ADDENDUM NO. 2

01-11-2024

Porterville College Sports Complex (PC Baseball/ Softball Field)
100 E College Ave,
Porterville, CA 93257

DARDEN PROJECT NO. 2118
DSA File Nos. 03-122694
DSA APPL. NO. 15-C1

**SD/X403
AD2-CX14**

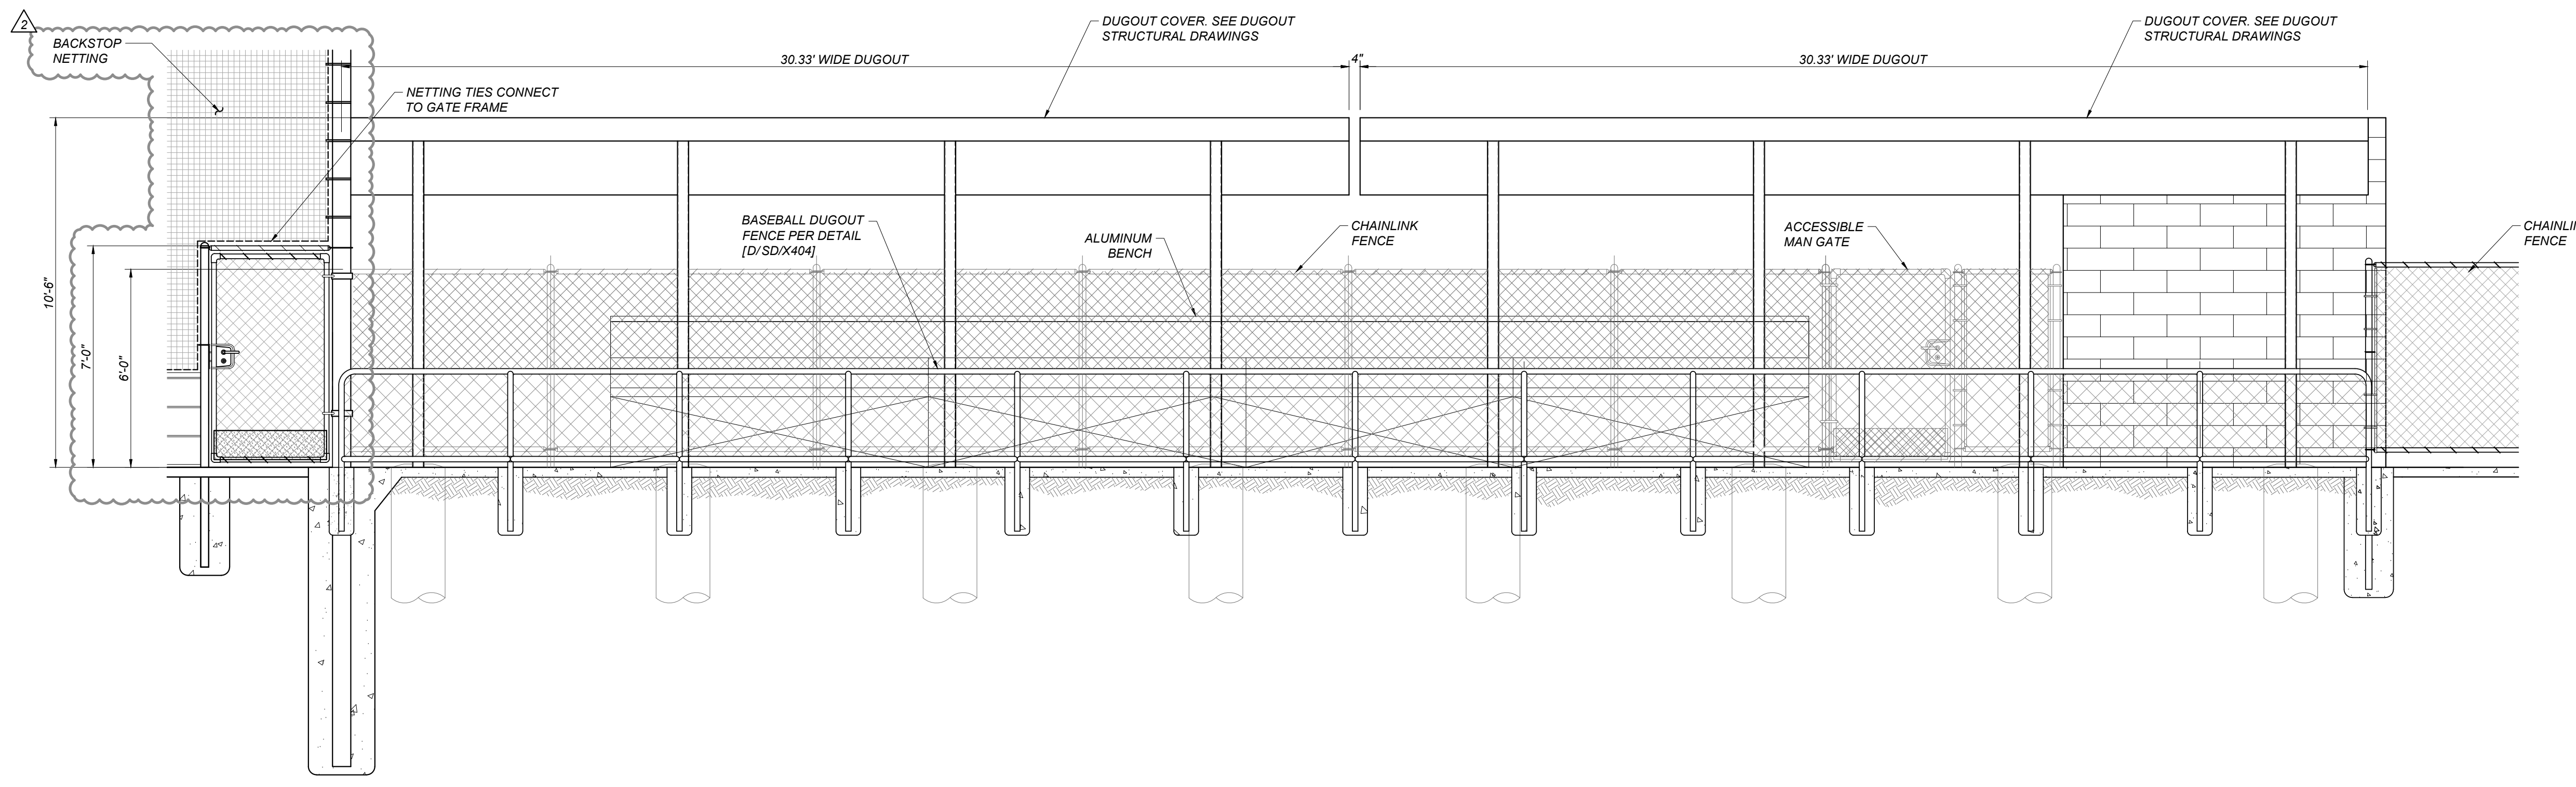
- AD2-C14 Refer to Sheet SD/X403 and attached Sheet AD2-CX14**
 - 1. Replace Sheet SD/X403 with the attached Sheet AD2-CX14
 - 2. Refer to clouded changes on Sheet AD2-CX14

SD/X404
AD2-CX15

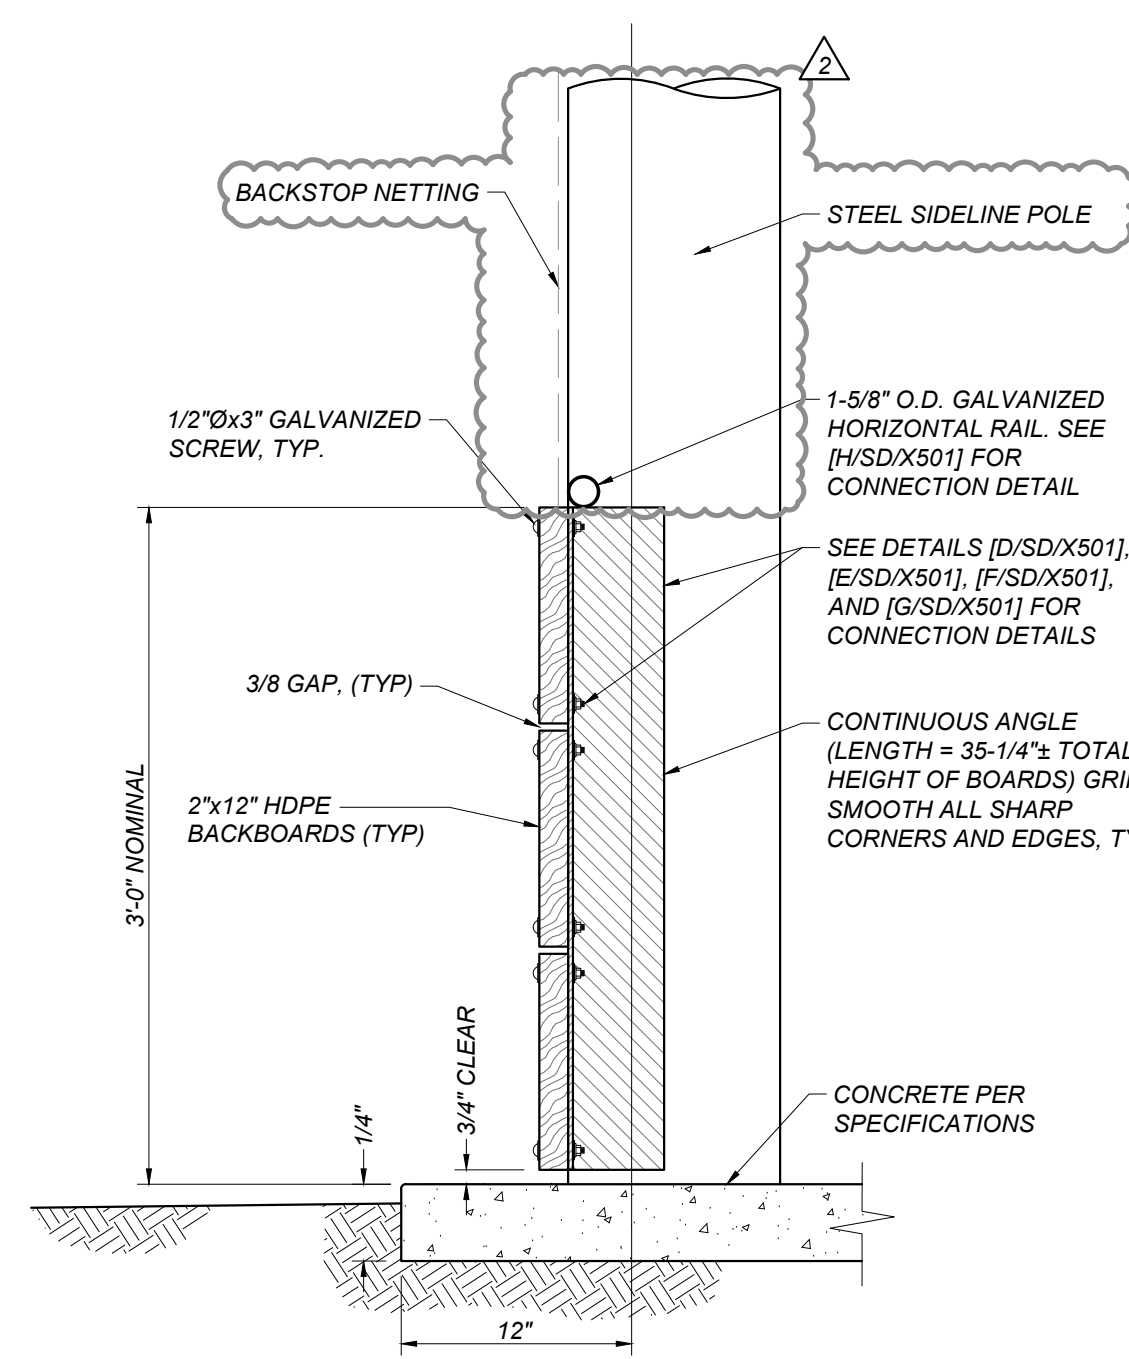
- AD2-C15 Refer to Sheet SD/X404 and attached Sheet AD2-CX15**
 - 1. Replace Sheet SD/X404 with the attached Sheet AD2-CX15
 - 2. Refer to clouded changes on Sheet AD2-CX15

SD/X601
AD2-CX17

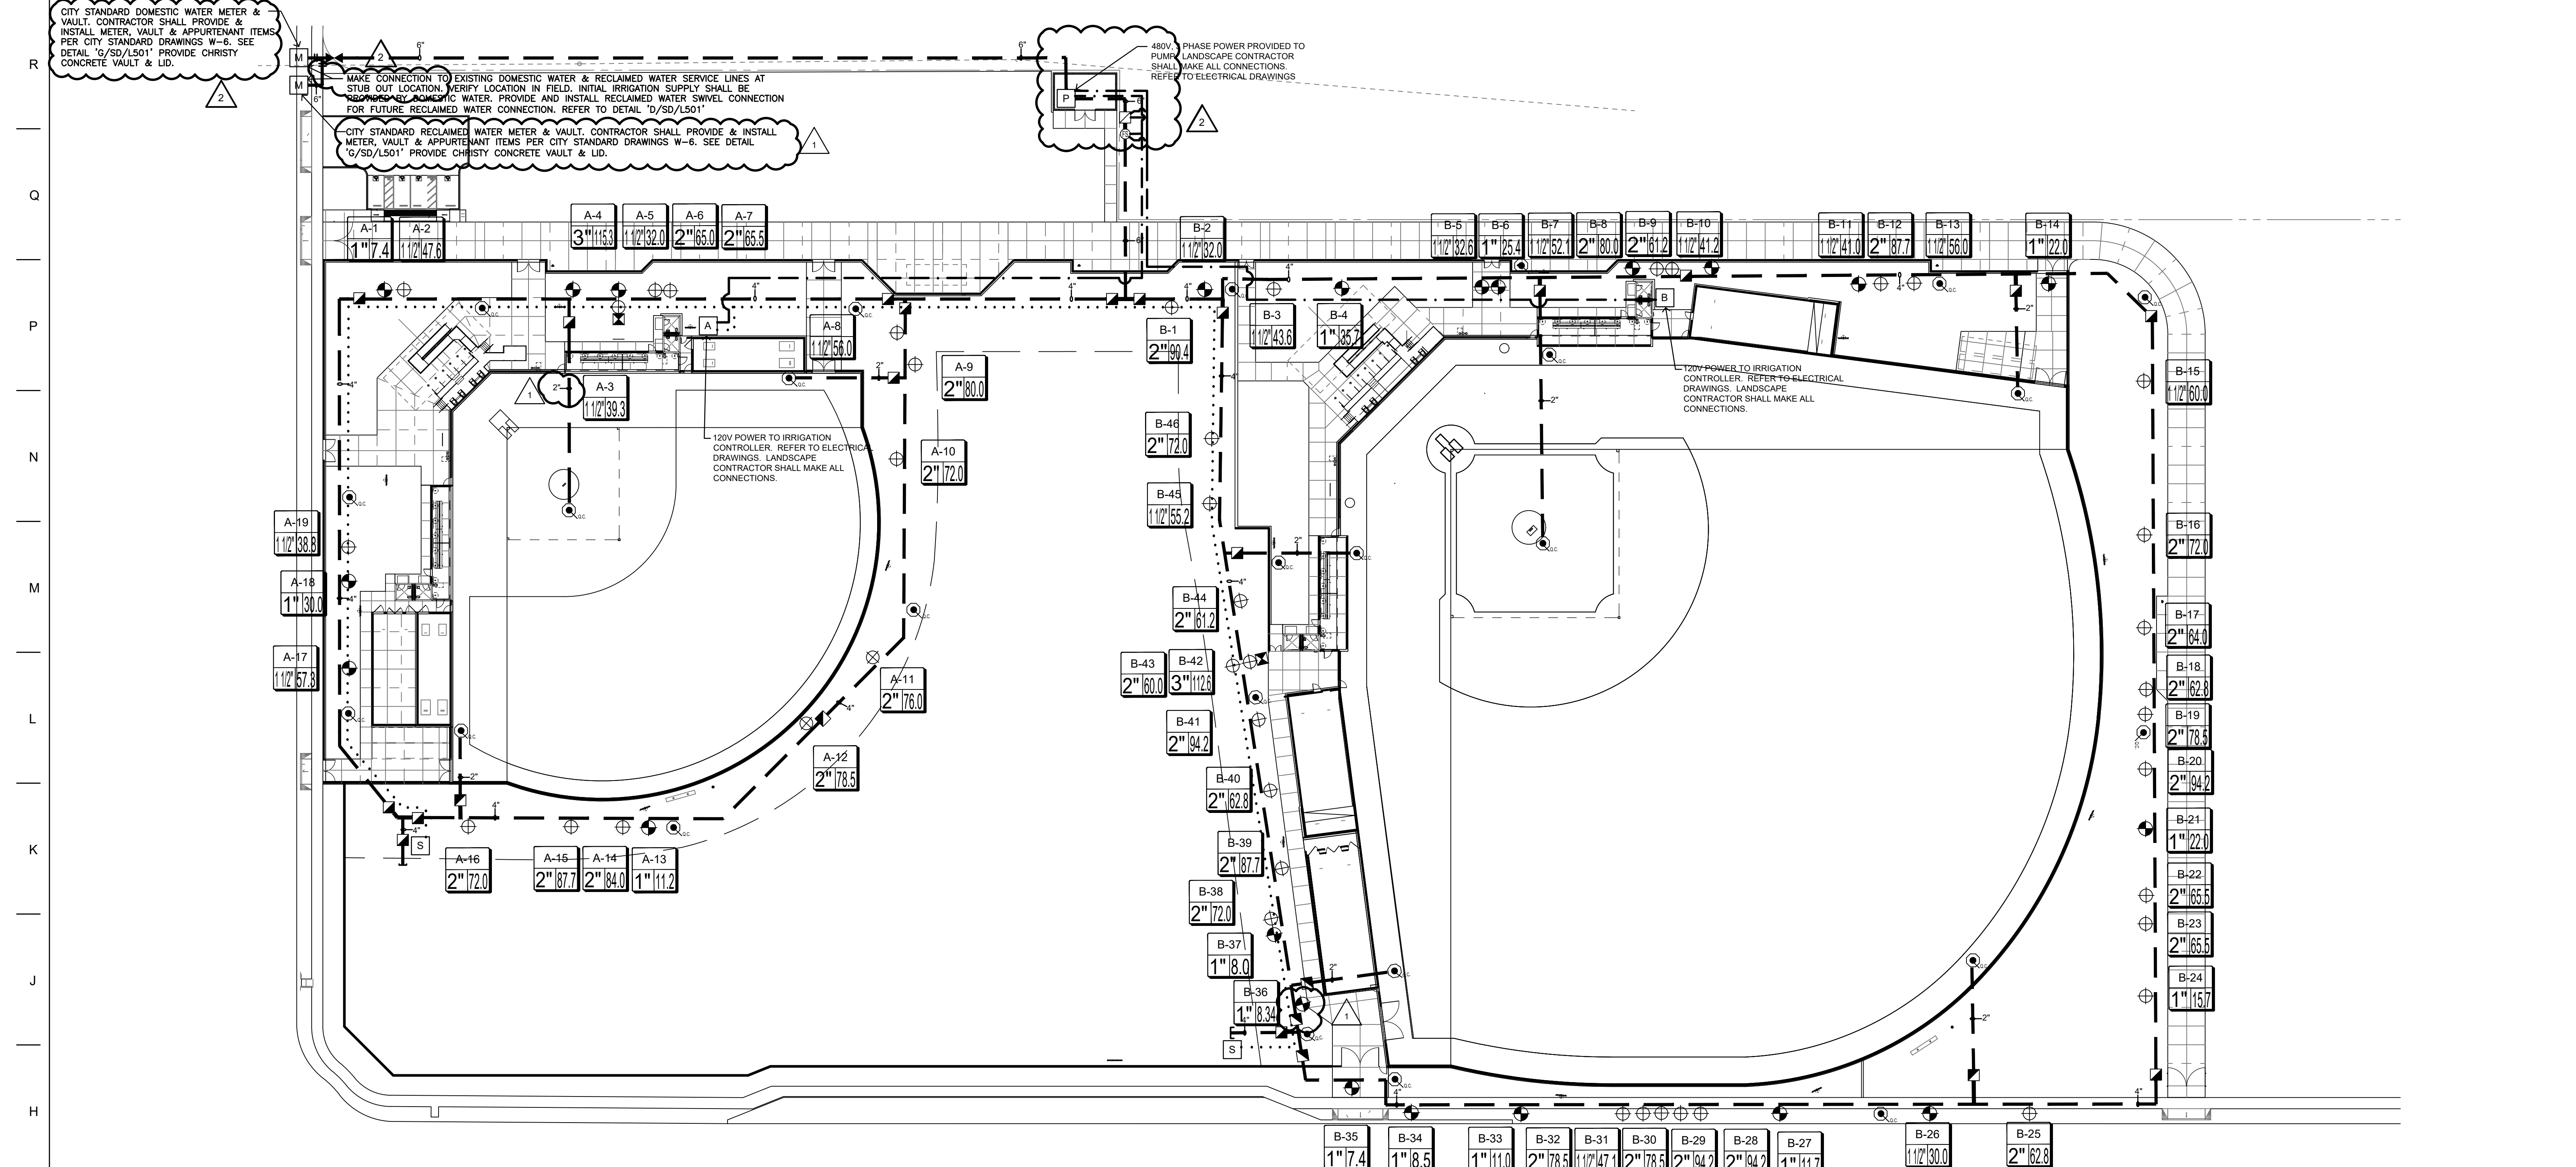
- AD2-C17 Refer to Sheet SD/X601 and attached Sheet AD2-CX17**
 - 1. Replace Sheet SD/X601 with the attached Sheet AD2-CX17
 - 2. Refer to clouded changes on Sheet AD2-CX17

DATE	REVIEWED BY
05-10-23	AD2-LX-01

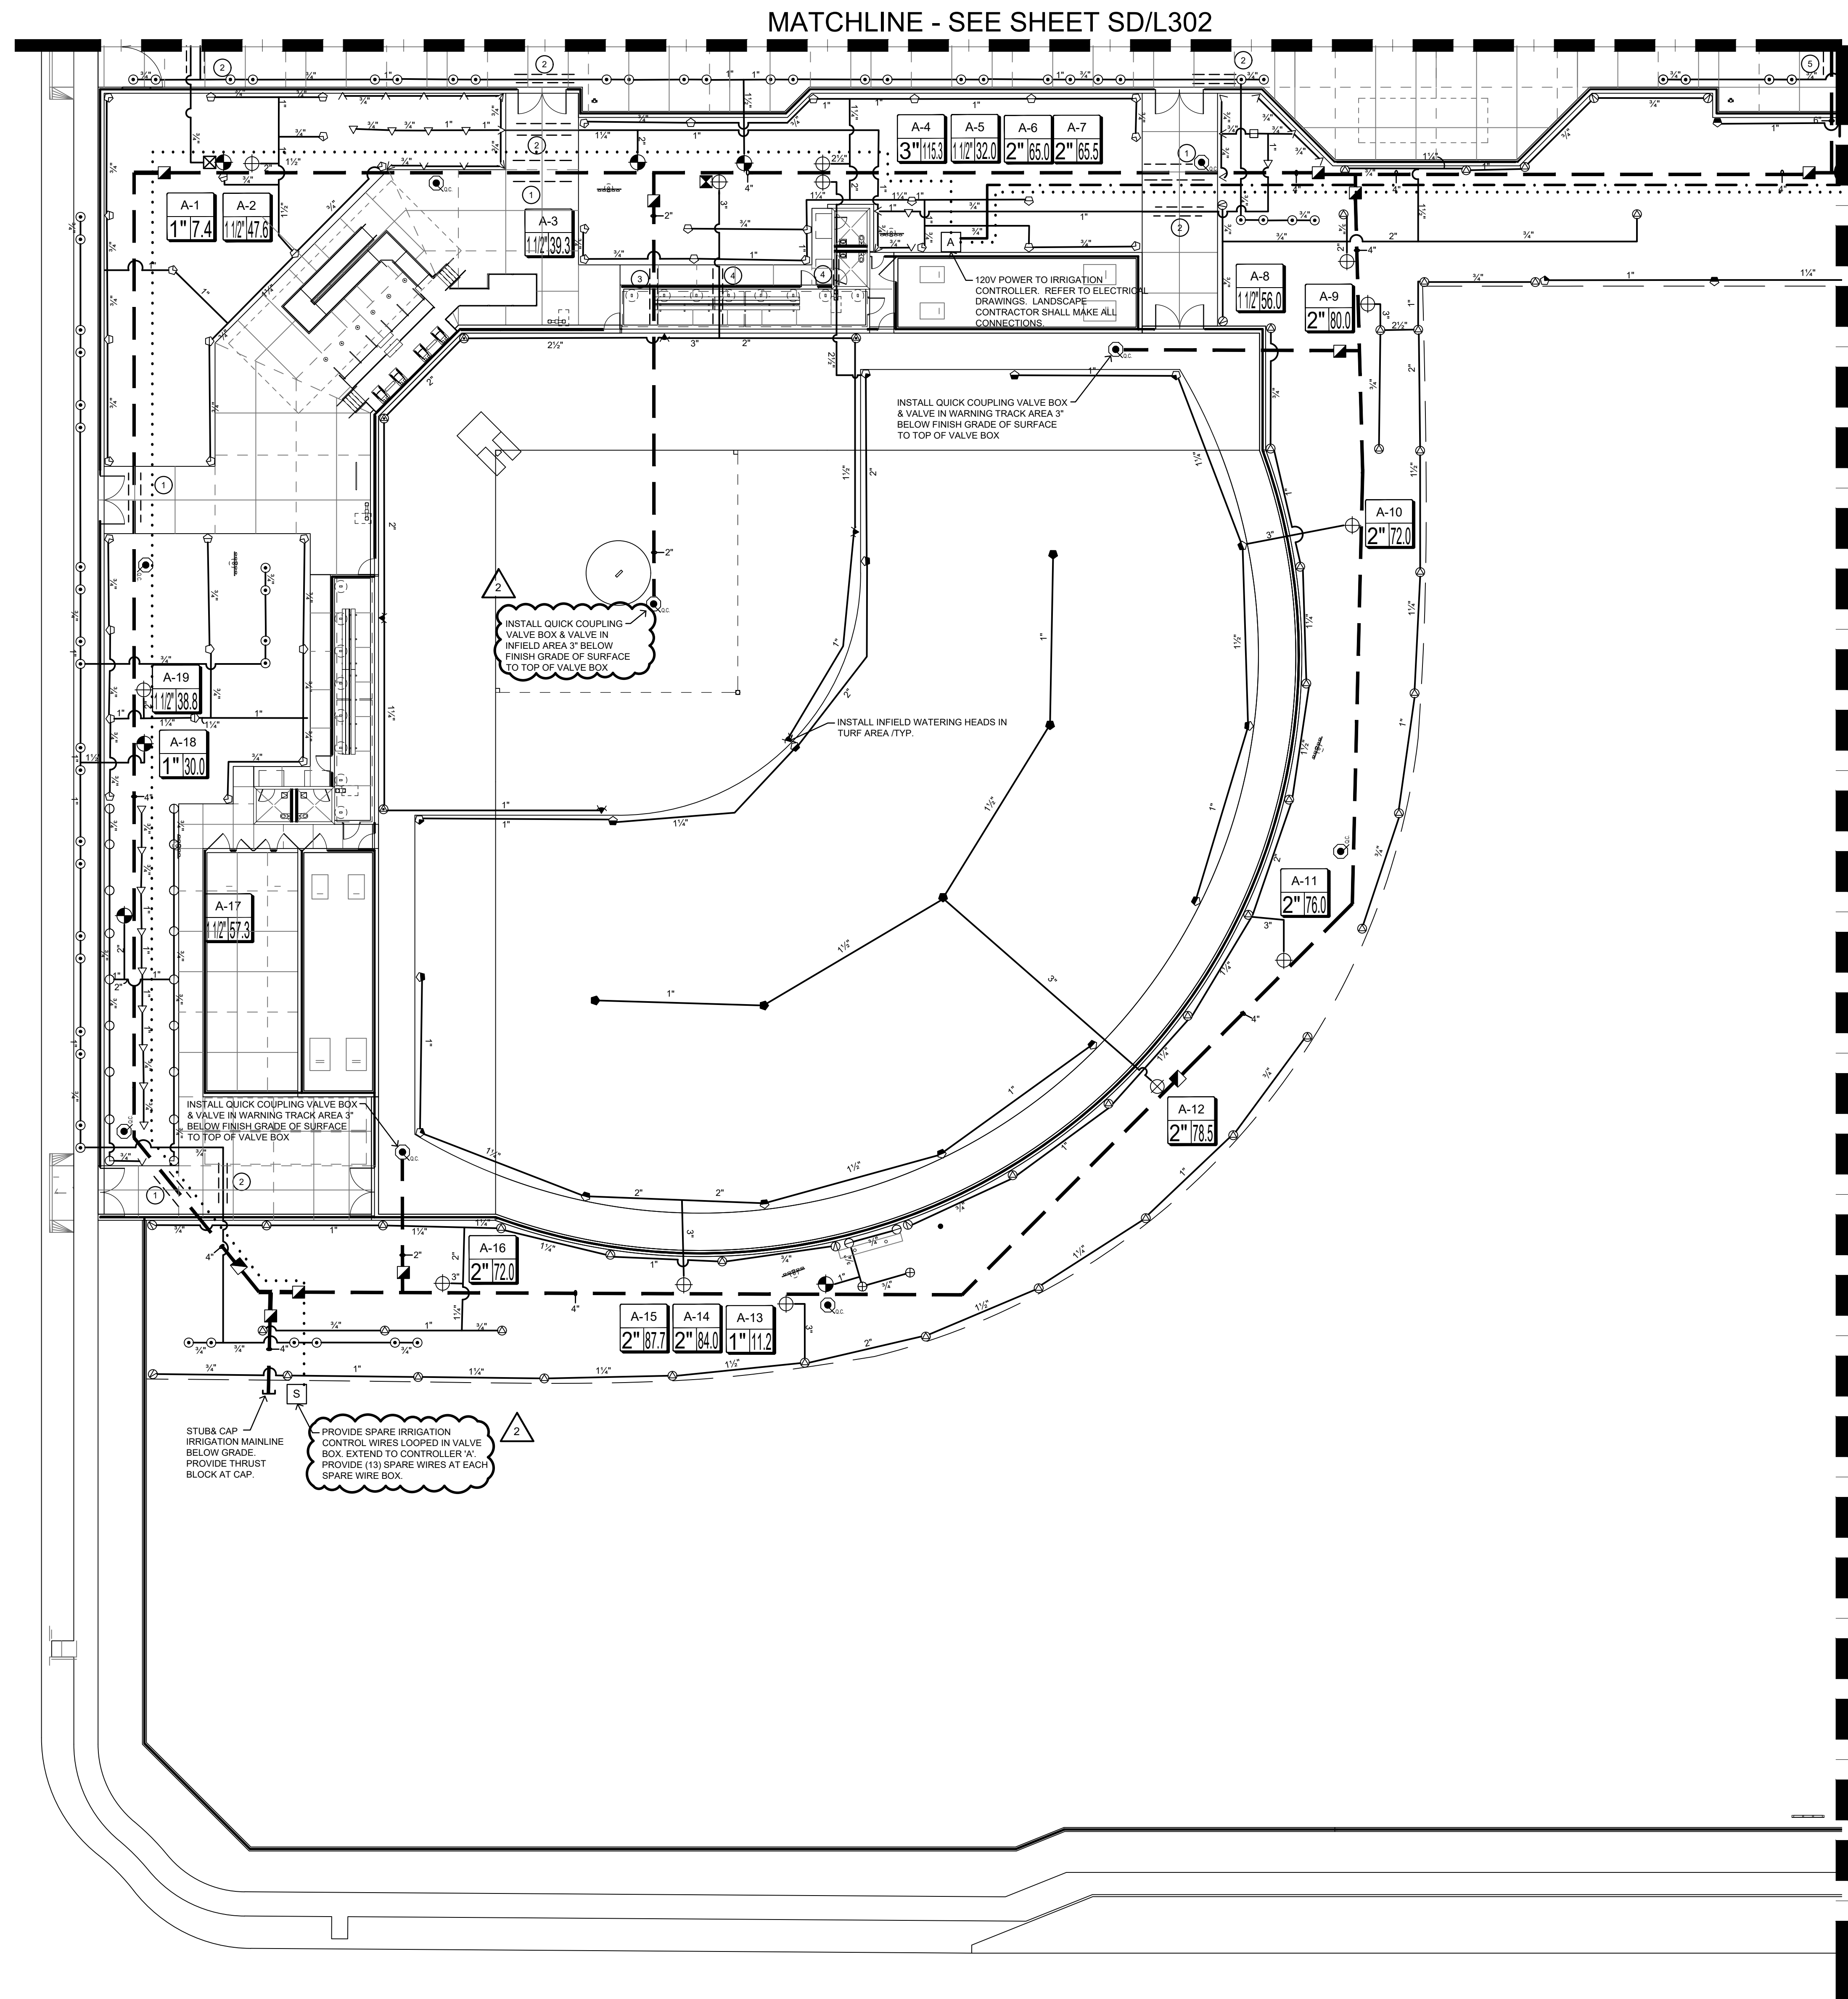
AD2-L01 Refer to Sheet SD/L100 and Attached Sheet AD2-LX-01 dated January 10, 2024

1. Replace Sheet SD/L100 with the attached Sheet AD2-LX-01
2. Revise the irrigation legend and the irrigation notes, clarify gate valves, plan notes.
3. Revise the irrigation plan notes at point of connection to existing domestic and reclaimed water lines.
